SUBJECT: To disable ink detection circuit

Priport VT1730

SUBJECT: Master Eject Jams

SUBJECT: Thermal Head Removal Procedure for N810-II

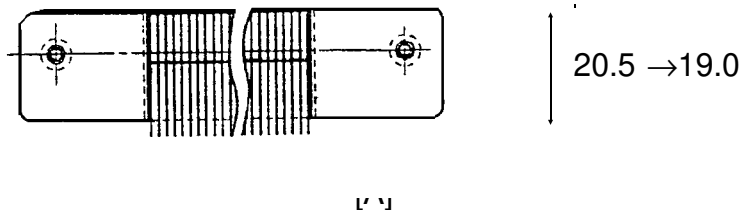
It was found that the antistatic brush sometimes interferes with master transportation and causes master feed jams. To ensure smooth master feed, the position of the antistatic brush [A] sticking on the inner cover [C] has been changed.

The sticking position is as shown below. Even if the antistatic brush does not contact the master surface, it functions to remove electrostatic charges on the master.

The antistatic brush assembly has been registered as a service part (C2174064). Please refer to MB No. 11.

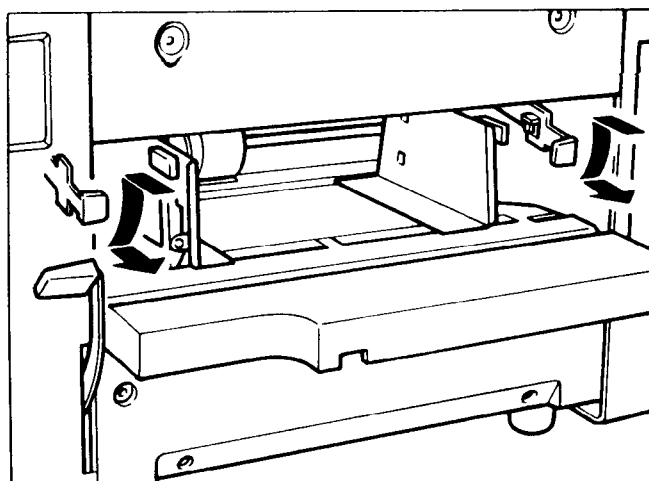
When 500 sheets of standard paper (80g/m²) is set on the paper table, paper misfeeds would occur. This is because not enough feed roller pressure is applied due to friction between the paper stack (leading edge side) and the lower paper feed guide which guides the leading edge of the paper stack.

In this case, advise your customer to change the position of the pressure adjustment levers, as shown below, to increase paper feed pressure.

We confirmed that even if the pressure adjustment levers are in the lower position, normal paper (70g/m to 200g/m) would be fed properly. So from August '93 production, the pressure adjustment levers have been set in the lower position (stronger pressure) in the factory.

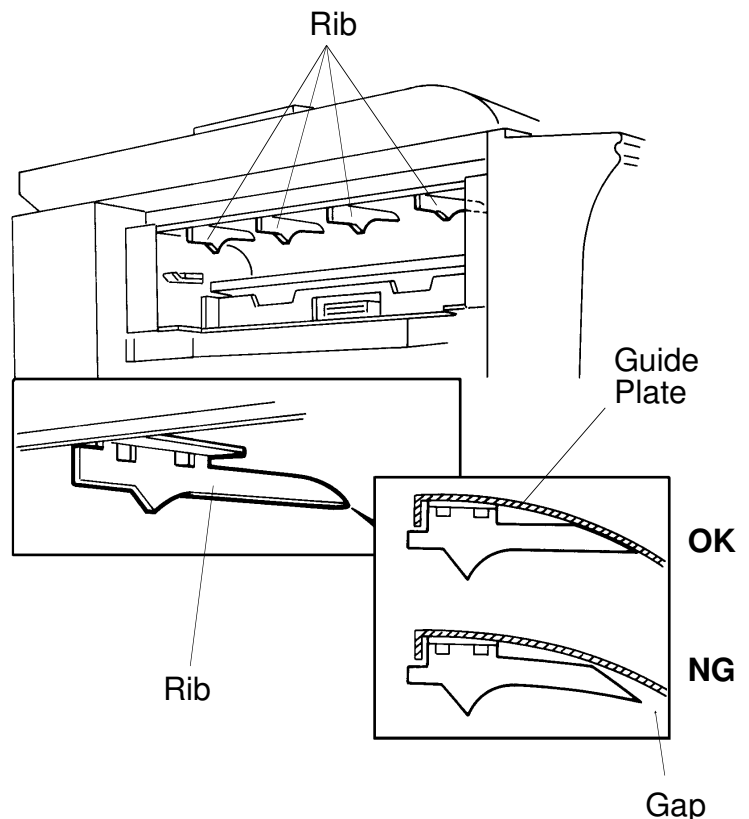
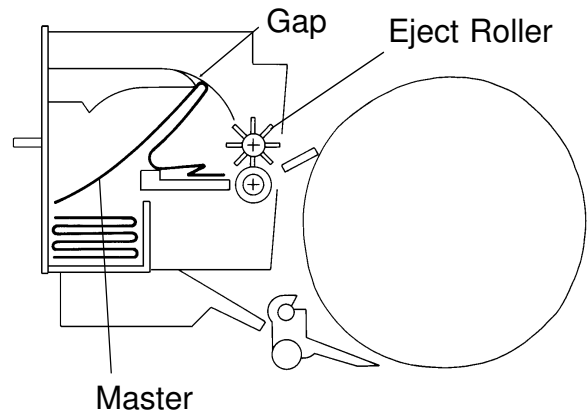
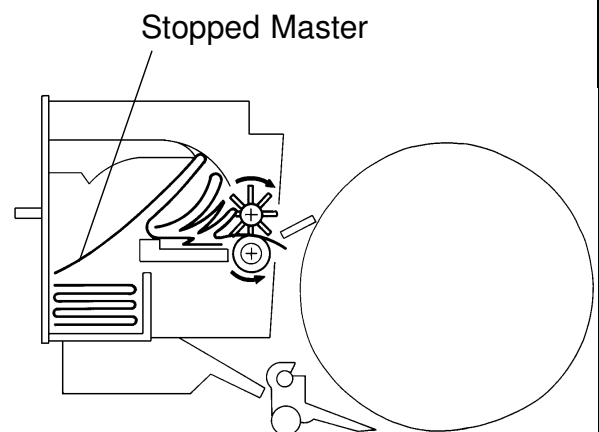
1. Frequent master eject jams at location "F".
2. The master wraps around the upper and/or lower master eject rollers.
3. "F" jam cannot be reset because the actuator (feeler) of the master eject sensor remains pushed down by the pressure plate. (The actuator comes under the pressure plate.)

There are 4 ribs to guide the ejected master in the master eject unit. There is a small gap at the leading edge of the ribs against the guide plate.

Due to a part variation, if the gap is too big, the master tends to be caught by the ribs. A jam or other problems may occur as per the following sequence:

1. While the master is being removed from the drum, the leading edge of the master goes properly into the master eject unit. At this point, however, while the pressure plate moves to compress the master in the eject box, the middle part of the master tends to rub against the ribs. If there are any gaps, the master is caught by the ribs. (The master therefore remains caught by the ribs.)

2. If no jam is detected by the machine after the above situation has occurred, the machine can carry out the next master eject. However, the next ejected master interferes with the master caught by the ribs and is stopped just behind the eject rollers.

Solution 1 (For the mass production units)

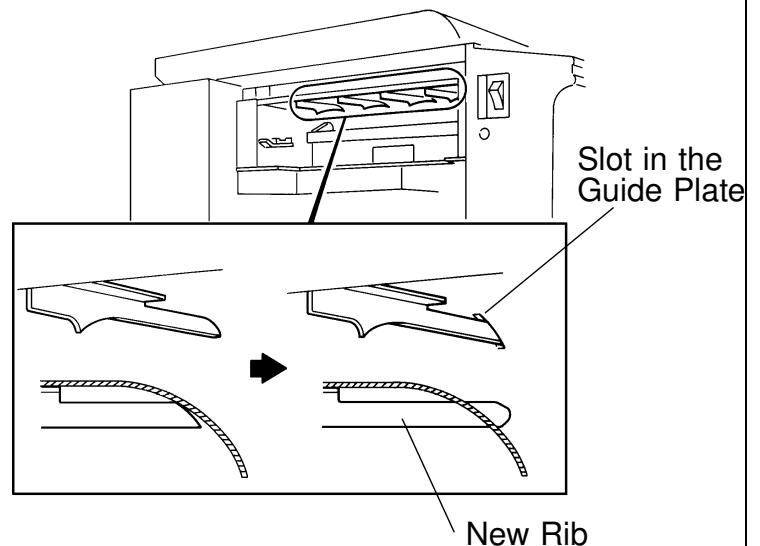
The ribs fixed (welded) to the guide plate have been changed as shown to prevent any gap at the leading edge. The part number of the guide plate (Guide Plate - Eject Unit) has been changed from #C2173565 to #C2173567.

The new guide plate will be applied into the production from June 1994.

Solution 2 (For the field units)

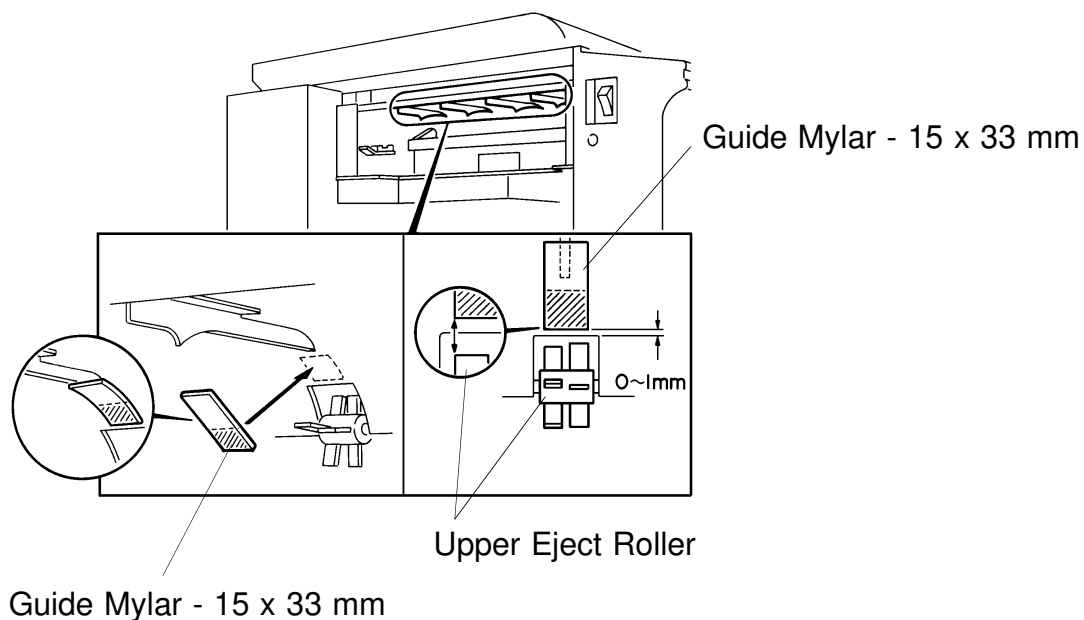
As a solution for the field units, a mylar strip (**Guide Mylar - 15 x 33 mm: P/N C2179500**) has been registered as a service part. Install the mylar strips on the leading edge of the 4 ribs to cover the gap as shown.

NOTE: 4 mylars are required for one unit.

Cross-section of the Bottom Part of the Ink Pump

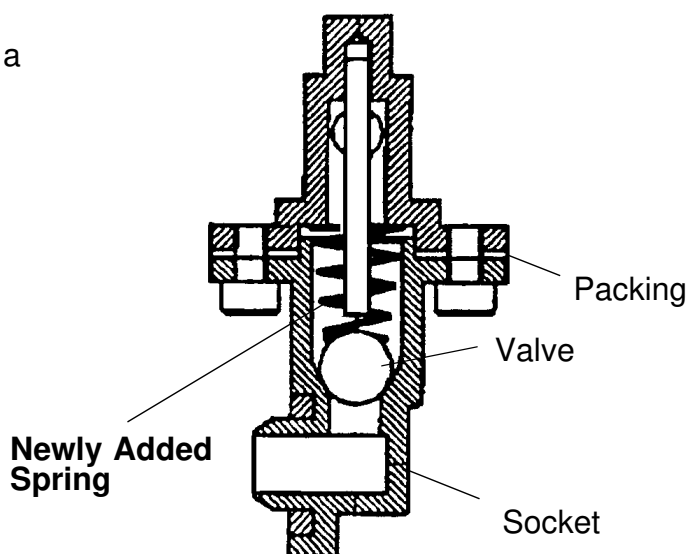
To ensure that all ink in the cartridge is supplied, a spring has been added inside the ink pump as shown to the right. The spring ensures that the small ball, which is used as a valve, is pushed back properly.

This modification has been applied from the September 1995 production runs of all Priport series models. The part numbers of the ink pump assemblies remain the same. (Note that the N850 and RN925 have been using the new type from the first mass production.)

SOLUTION IN THE FIELD

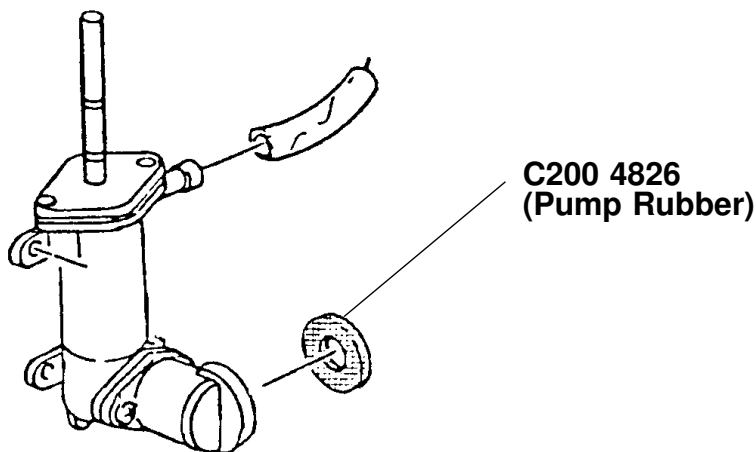
For the field machines, you can install the spring after removing the socket (with two screws). (It takes longer to replace the whole pump assembly.)

NOTE: 1. There is a packing between the socket and housing (see the illustration on the previous page). If it is damaged, you may have to replace the packing at the same time. (Normally, this is not required.) The part number is:

2. A rubber packing is used as shown below in order to ensure that the nozzle of the ink cartridge tightly contacts the pump socket. Check if this part is dislocated. The rubber packing used in the N810, the N865, and the other later models is adhered with glue, but it is not adhered for the other older models.

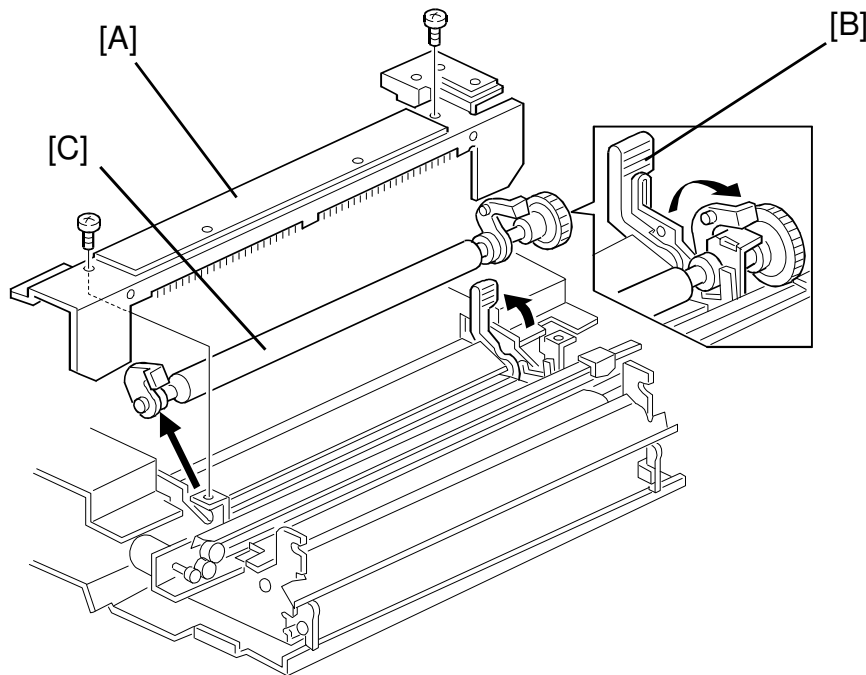
A cutout has been made in the rear side (non-operation side) frame of the plotter unit. (The part number: C2174102, remains the same, but all service parts are the new type only.) This enables the removal of the thermal head (with the bracket) without having to forcibly spread out the side frames. Refer to the new thermal head removal procedure.

This modification will be applied from the April 1996 production run.

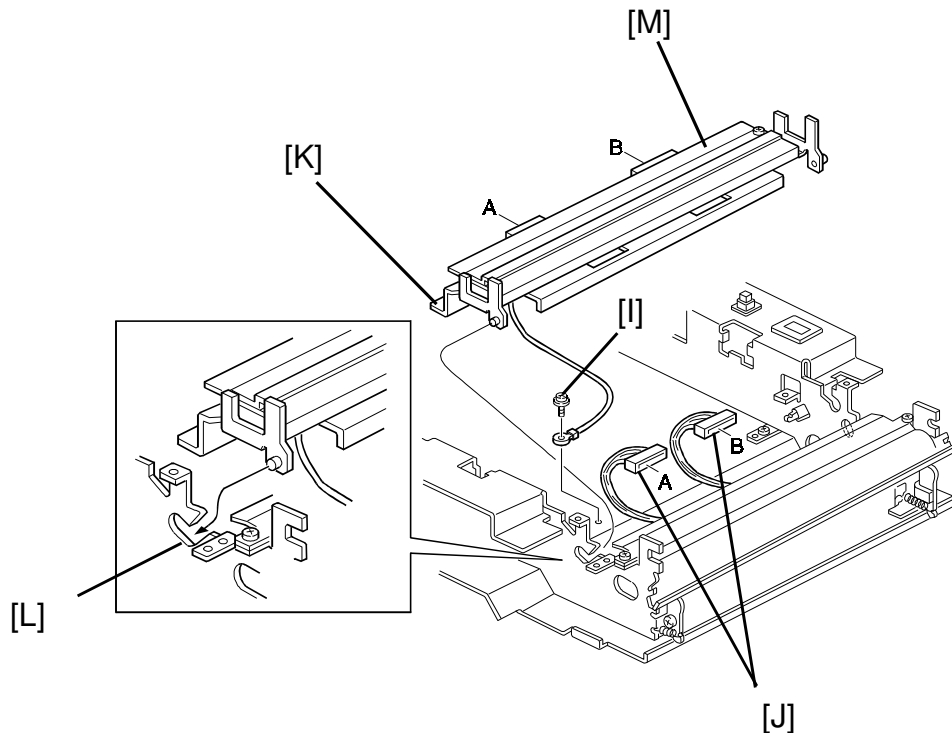
10. Unhook the pins on non-operation sides of the thermal head bracket [K] through the cutout [L] and remove the bracket (with the thermal head).

NOTE: The cutout [L] has been newly added.

For N810 and N810-II Models

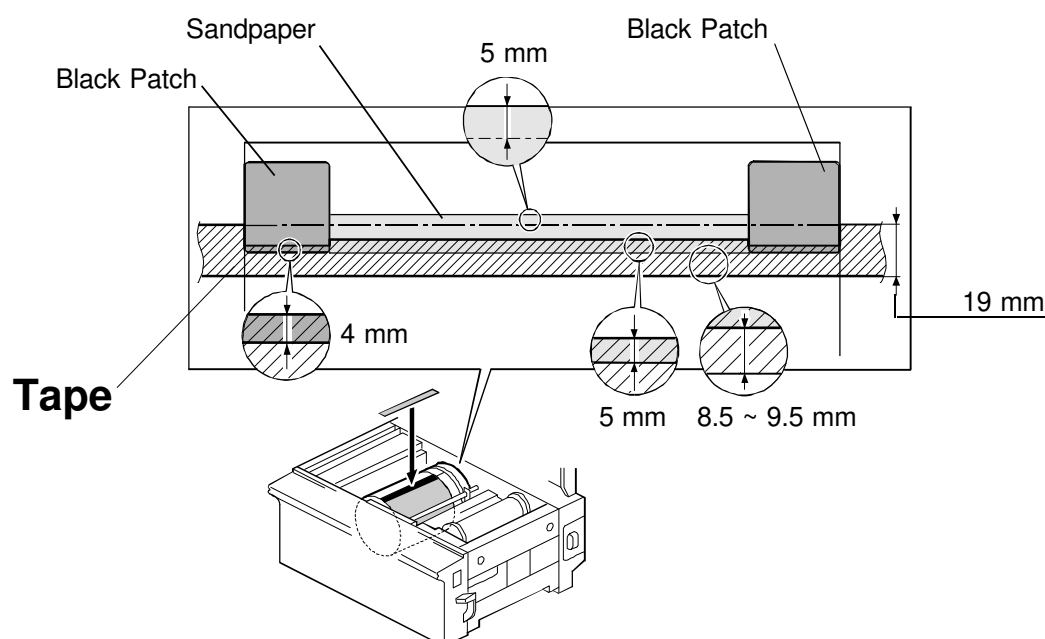
- Cut the tape where it covers the sandpaper as shown. (The indicated area must be left as shown to hold the tape on the screen firmly.) Be careful not to damage the cloth screen surface.
- **Also, cut the tape where it covers the black patches (for the drum master detection sensor) as shown. If they are covered, drum master detection does not work properly.**
- Cut both edges of the tape at the edge of the metal screen. Do not let the tape ride over the drum flanges.
- Even if the sandpaper is not used on the cloth screen (the old type cloth screen), install tape at the same position by measuring the distance from the edge of the black patch to the lower edge of the tape (between 8.5 and 9.5 mm).

For NA33 model

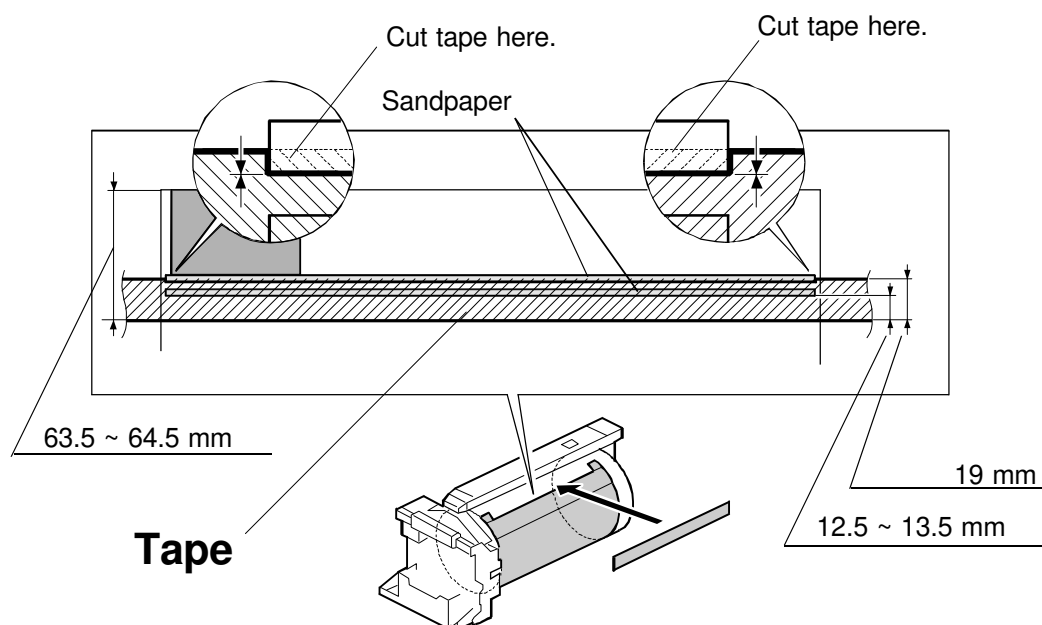
- Cut the tape where it covers the upper strip of sandpaper as shown. Be careful not to damage the cloth screen surface.
- Cut both edges of the tape at the edge of the metal screen. Do not let the tape ride over the drum flanges.

For NA3 and NA2 Models

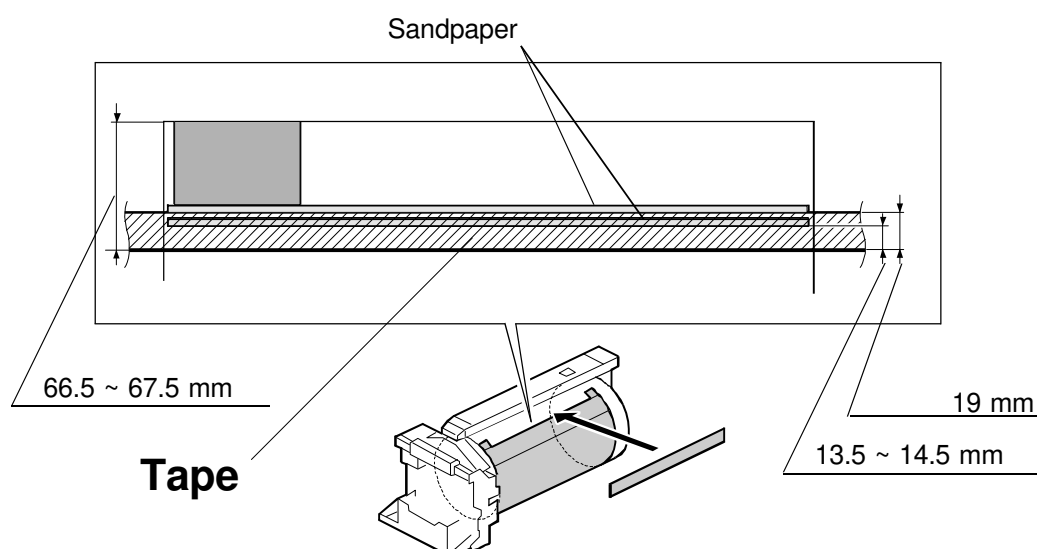
- The position of the tape is slightly different from that for the NA33 model since the specification of the leading edge blank margin is different. (The position of the sandpaper is also different.) The upper edge of the tape should meet between the two strips of sandpaper. You do not have to cut the tape (unlike in the case of the NA33 model).

- Cut both edges of the tape at the edge of the metal screen. Do not let the tape ride over the drum flanges.
- Even if the sandpaper is not used on the cloth screen (the old type cloth screen), install the tape at the same position by measuring the distance from the edge of the cloth screen to the lower edge of the tape (between 66.5 and 67.5 mm).

- Since the specification of the leading edge blank margin for the NA2 model is 10 mm (8 mm for the NA3 model), it is permissible to install the tape 2 mm lower than the position indicated above (NA2 only).

For RN925, NB2, N850, N860, N865, N915, N935, and N955 Models

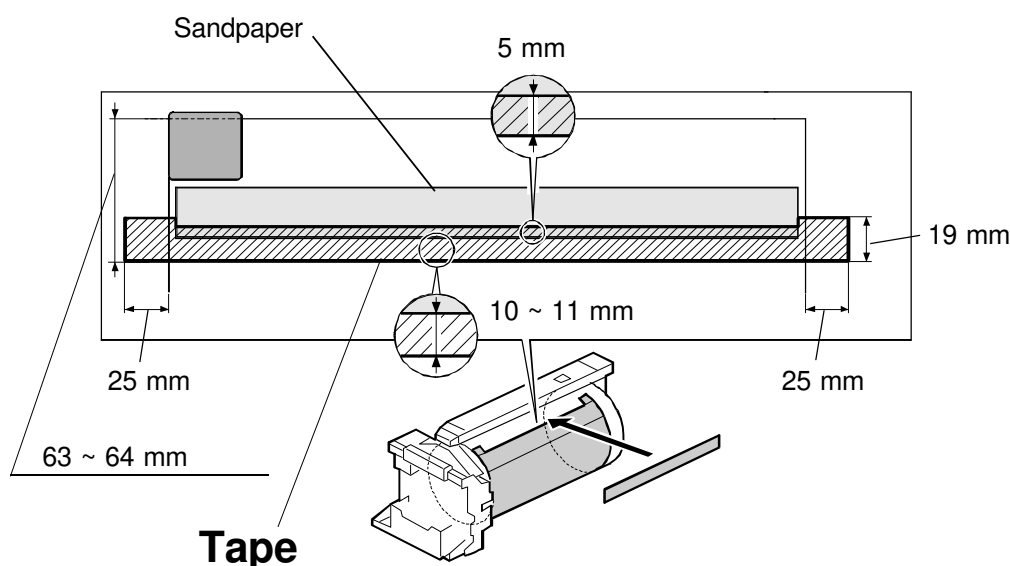
- Cut the tape where it covers the sandpaper as shown. (The indicated area must be left as shown to hold the tape on the screen firmly.) Be careful not to damage the cloth screen surface.
- Cut both edges of the tape as indicated.
- Even if the sandpaper is not used on the cloth screen (the old type cloth screen), install tape at the same position by measuring the distance from the edge of the cloth screen to the lower edge of the tape (between 63 and 64 mm).
- Since the specification of the leading edge blank margin for the N915/935/955 model is 10 mm (5 mm for the other models), it is permissible to install the tape 5 mm lower than the position indicated above.
